631.30290-L01-Council RFI-Traffic-v2.0-20220428.docx

The Store Mixed Use Development (DA2021/01530) City of Newcastle Request for Additional Information Traffic and Transport Response

REQUEST FOR ADDITIONAL INFORMATION

Development Application No:	DA2021/01530
Land:	Lot 11 DP 1270693 Lot 2 DP 1271240
Property Address:	854 Hunter Street Newcastle West NSW 2302
Proposed Development:	Mixed use development, including shop top housing with 365 dwellings, ground floor retail premises, commercial premises and a basement

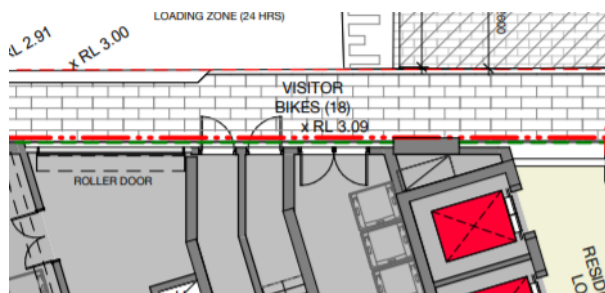
It is noted that the applicant has not detailed the proposed allocation (distribution) of parking spaces for the proposed residential apartments.

In response Council advises that 'market demand' in itself is not considered to be sufficient justification for the departure from Council's NDCP. Furthermore, the oversupply of resident parking does not align with the objectives of Council's Parking Plan 2021-2030, which aims to increase active and public transport use in the city centre. Council is also presently reviewing its parking rates for residential development in the CBD and early indications suggest parking rates will be further reduced to align with this strategic direction. On this basis Council does not support the a significant parking surplus of 58 parking spaces but may entertain a minor parking variation.

3.2. Bicycle parking

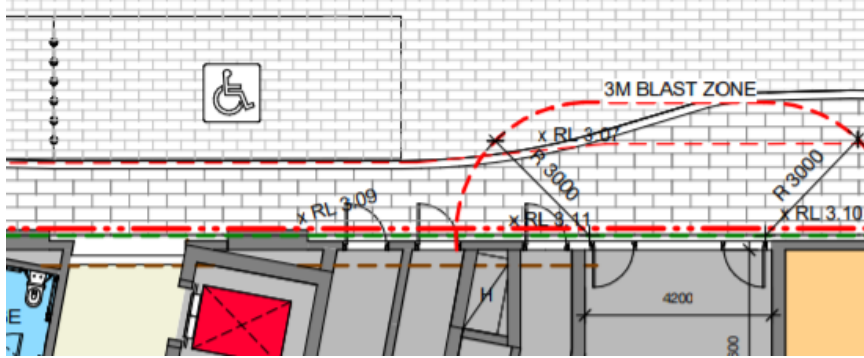
The applicant proposes to provide 356 storage cages for residents within the basement level and Level 4. The remaining 58.9 (59) spaces comprise 22 'Class 2' and 37 'Class 3' spaces. The 'Class 2' bicycle spaces and end of trip facilities (showers and change room / lockers) would appear not to be detailed on the submitted plans, while the 'Class 3' bicycle parking spaces are proposed to be located within the public plaza area adjacent to the eastern tower.

The submitted plans are to be amended to detail the location of the 'Class 2' bicycle parking and end of trip facilities.

Level 00 Plan

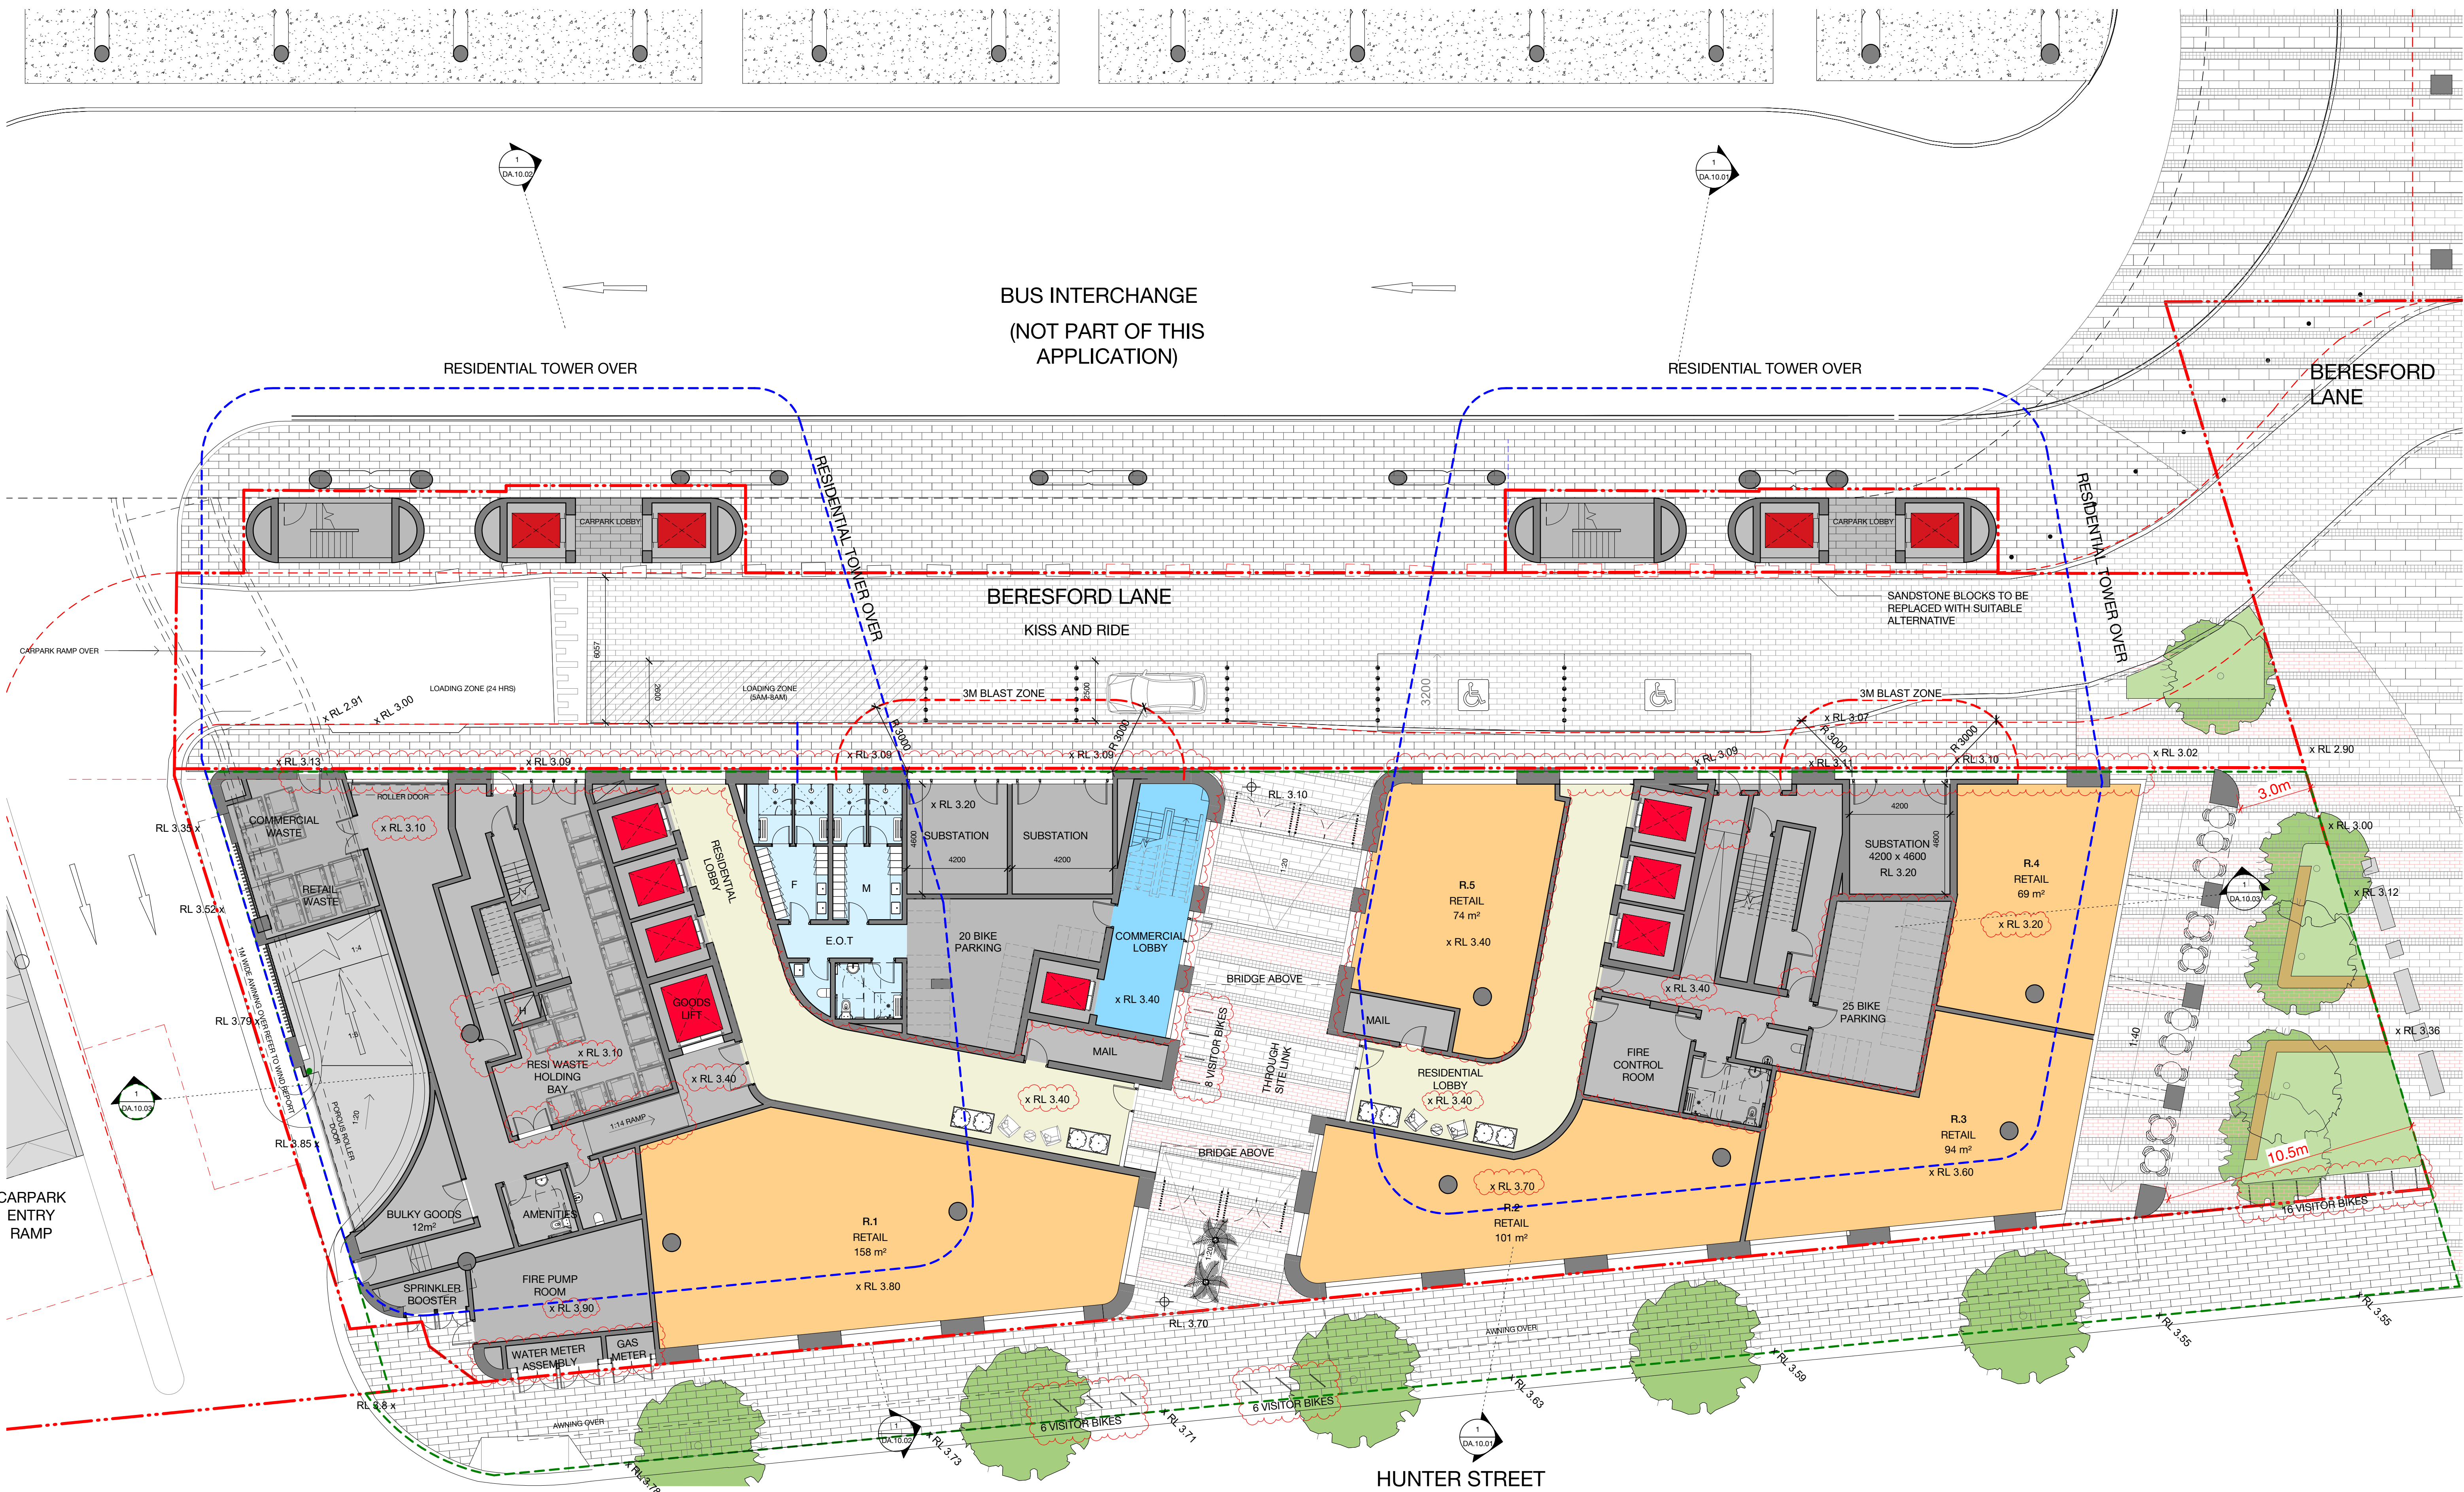
The ground floor plan DA.03.00 is to be amended to include design finished floor levels at the proposed stairwells and residential lobbies to verify compliance with the above requirement.

Design floor levels are not provided in the ground floor plan DA.03.00 for a number of proposed utility and commercial rooms. The ground floor plan shall be amended to include finished floor levels for all utility (switch, fire pump, waste, bulky goods, stairwells, substations) and retail (R.2 at Beresford Ln) rooms.
